適航指令發布單

民航局AD編號 AD Number	CAA-2016-11-008	發布日期 Date issued	2016/11/17
適用之航空產品 Applied to (models, serial numbers or part numbers, as applicable)	The Boeing Company Model 777-200, -200LR, -300, and -300ER series airplanes, certificated in any category.		
主旨摘要	FUEL - Left and Right Engine Fuel Spar Valve Control Relay and Wiring - Modification		
民航局 CAA <input type="checkbox"/> 本國產品 Native products <input type="checkbox"/> 其他個案 Other	設計國民航主關機構 Original Authorities <input checked="" type="checkbox"/> FAA <input type="checkbox"/> EASA <input type="checkbox"/> Brazil <input type="checkbox"/> Transport Canada Civil Aviation <input type="checkbox"/> DGAC <input type="checkbox"/> Germany LBA <input type="checkbox"/> CAA-NL <input type="checkbox"/> UK CAA <input type="checkbox"/> Japan CAB <input type="checkbox"/> CAA of Israel <input type="checkbox"/> Other _____		
	設計國AD編號 Original AD number	2016-21-05

[Docket No. FAA-2015-7527; Directorate Identifier 2015-NM-094-AD; Amendment 39-18686; AD 2016-21-05]

Airworthiness Directives; The Boeing Company Airplanes

Figure 1 to paragraph (h) of this AD: *Wiring Installation - Right Engine Fuel Spar Valve*

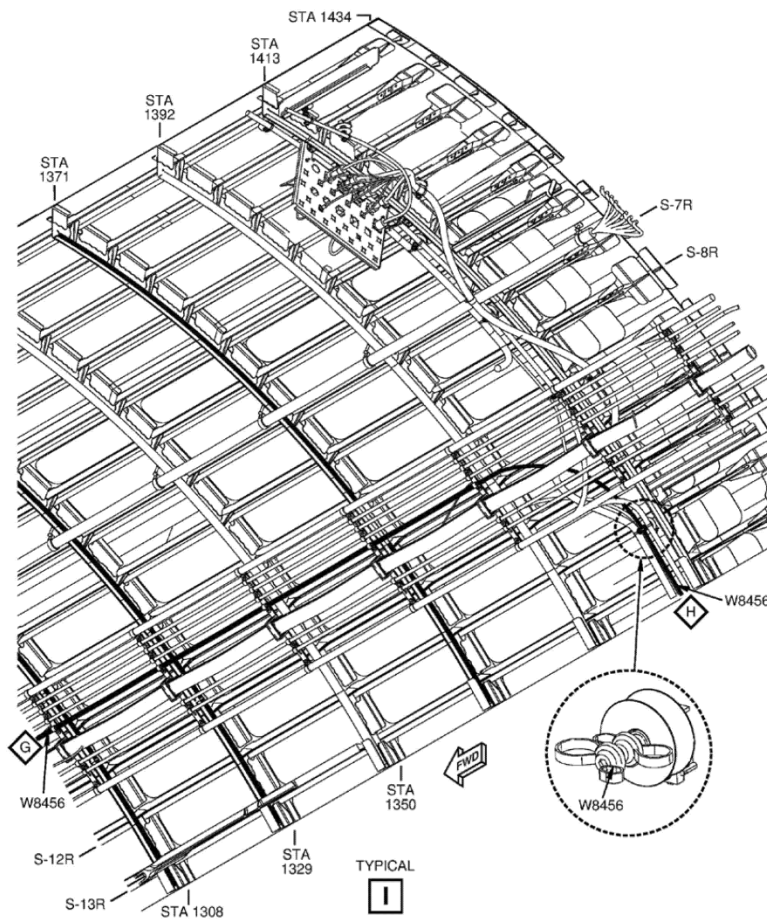
We partially agree with the commenter's request. We cannot include Boeing Service Bulletin Information Notice 777-28-0061, IN 03, dated November 16, 2015, as an appropriate source of service information in this AD because it is not an FAA-approved document. However, we acknowledge that for certain airplanes, Figure 22, Sheet 9, of Boeing Special Attention Service Bulletin 777-28-0061, Revision 2, dated May 4, 2015, includes an editorial error, which shows incorrect wire routing. Boeing Service Bulletin Information Notice 777-28-0061, IN 03, dated November 16, 2015, allows for a modification of Group 2 airplanes that meets the requirements of the AD without an additional burden to operators. We have included a corrected figure in paragraph (h) of this AD to address this issue.

(1) Where Boeing Special Attention Service Bulletin 777-28-0061, Revision 2, dated May 4, 2015, specifies to use Figure 22, Sheet 9, for the wiring installation of the right engine fuel spar valve, this AD requires using figure 1 to paragraph (h) of this AD.
